# Access Compliance Report

## Public Rights-of-Way

### (Curb Ramps)

Intersection ID: N/A	Main Street: SIKES_PL	Cross Street: N/A	Location: NE
ADA ID: F76551AA5D97	Ramp Type: Perp	Initial Pass/Fail: Fail	Overall Compliance: No
Severity Score: 21.25			
Codes/Mitigation Info/Possible Solution		Field Measurements/Component Compliance

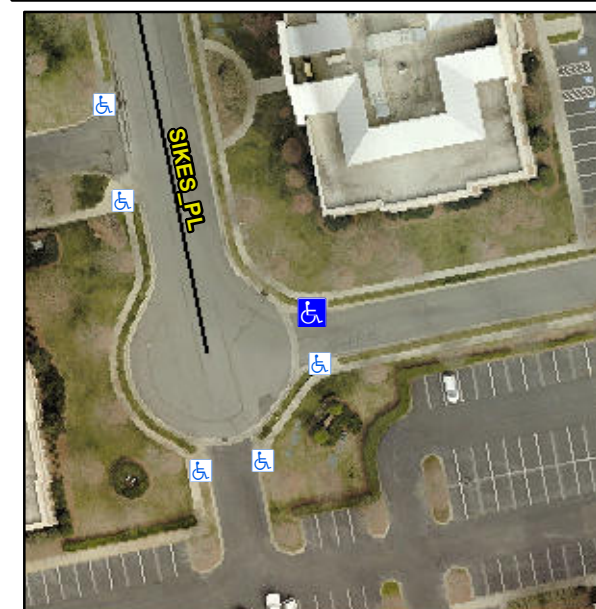
**R304.5.1, R304.2.2**

Compliance	Description	Data	Compliance	Description	Data
N/A	Ramp Length (in)	52.0	No	Ramp Slope (%)	10.3
No	Ramp Width (in)	44.5	Yes	Ramp XSlope (%)	1.0
N/A	Flare Type LT	N/A	N/A	Flare Type RT	N/A
N/A	Flare Slope LT (%)	N/A	N/A	Flare Slope RT (%)	N/A
N/A	Flare Traversable LT?	N/A	N/A	Flare Traversable RT?	N/A
N/A	Landing Length (in)	N/A	N/A	DWS Provided?	N/A
N/A	Landing Width (in)	N/A	N/A	DWS Contrast?	N/A
N/A	Landing Slope (%)	N/A	N/A	DWS Length (in)	N/A
N/A	Landing X Slope (%)	N/A	N/A	DWS Full Width?	N/A
N/A	Landing Curb? (Y/N)	N/A	N/A	DWS Offset (in)	N/A
N/A	Shared Landing?	N/A			
N/A	Gutter Ponding?	N/A	N/A	Gutter Slope (%)	N/A
N/A	Gutter Lip Ht (in)	N/A	N/A	Gutter X Slope (%)	N/A
N/A	Painted X Walk1?	No	N/A	Painted X Walk2?	N/A
	X Walk 1 Direction	To S		X Walk 2 Direction	N/A
N/A	X Walk 1 Width (in)	N/A	N/A	X Walk 2 Width (in)	N/A
	X Walk 1 Slope (%)	1.1		X Walk 2 Slope (%)	N/A
	X Walk 1 X Slope (%)	0.6		X Walk 2 X Slope (%)	N/A

**Remove & Replace Entire Ramp.**
